Product Change Notice (PCN)

PCN Number: PCN-0450007R-01

Product(s) Affected: SJ-43504-SMT-TR

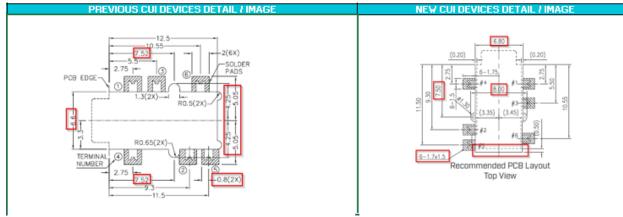
Description of Change:

1. Minor Housing Differences

2. Minor PCB Differences

3. Housing and Terminal material Differs

DESCRIPTION	MATERIAL	PLATING/COLOR
	MATERIAL	DI ATTAIC	terminal 1	C5210 t=0.20	gold flash over nickel
	MATERIAL	PLATING	terminal 2	C5210 t=0.20	gold flash over nickel
terminal 1	copper alloy	gold flash	terminar c		
terminal 2	copper alloy	gold flash	terminal 3	C5210 t=0.20	gold flash over nickel
terminal 3	copper alloy	gold flash	terminal 4	C5210 t=0.20	gold flash over
terminal 4	copper alloy	gold flash	LEITIIII 4	G0210 (-0.20	nickel
terminal 5	copper alloy	gold flash	terminal 5	C2680-EH t=0.20	gold flash over nickel
terminal 6	copper alloy	gold flash	terminal 6	C2680-EH t=0.20	gold flash over nickel
plastic	PA6T or equivalent		housing	PA9T (UL94V-0)	black
